MONTGOMERY COUNTY HISTORIC PRESERVATION COMMISSION
STAFF REPORT

Address:	7017 Sycamore Ave., Takoma Park	Meeting Date:	1/22/2025
Resource:	Contributing Resource Takoma Park Historic District	Report Date:	1/15/2025
Applicant:	Rolf Reichle & Amy Schwenkmeyer Brian McCarthy, Architect	Public Notice:	1/8/2025
Review:	Historic Area Work Permit	Tax Credit:	Partial
Permit Number:	1075104	Staff:	Dan Bruechert
Proposal:	Alterations to front porch, partial demolition and new construction of rear deck

Staff recommends the HPC approve the HAWP application.

Figure 3: Proposed site plan with topographic lines.

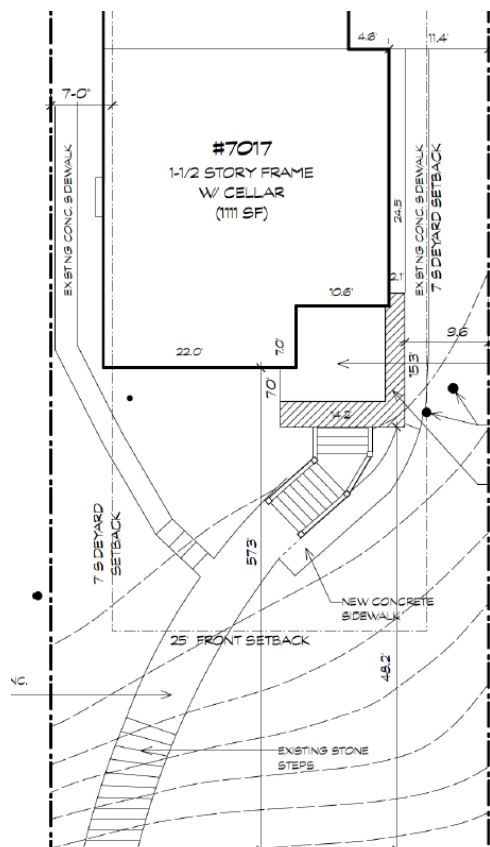
At the Preliminary Consultation, Staff expressed some reservations regarding the proposed run of the front stairs. Most porches in the Takoma Park Historic District have either front loading or side loading stairs. Rarely are these stair runs anything but straight. The subject property has some site-specific constraints that led to the current proposal including, the lot slope, existing hardscaping, and limited visibility from the public right-of-way. The proposed 41° (forty-one degree) turn in the proposed stairs allows the porch to align with the existing concrete walk. This walk will connect the proposed stairs to the existing stone stairs along Sycamore Ave. As the lot slopes to the southwest, requiring a straight stair run would likely require an additional one or two stairs to accommodate the grade (see *Figure 2*, below). The porch stairs would then have to project even further into the yard than the current proposal, further impacting the existing landscape. Finally, there is a 5' (five foot tall) stone retaining wall at the edge of the subject property.

At the Preliminary Consultation, the HPC found that this design solution was the correct one and that while the stairs would obscure some of the front porch design, it would not detract from the house design or the surrounding district. Based on these considerations and the feedback from the HPC, Staff recommends the HPC approve the porch design under 24A-8(b)(2) and (d), the *Design Guidelines*, and Standard 2.
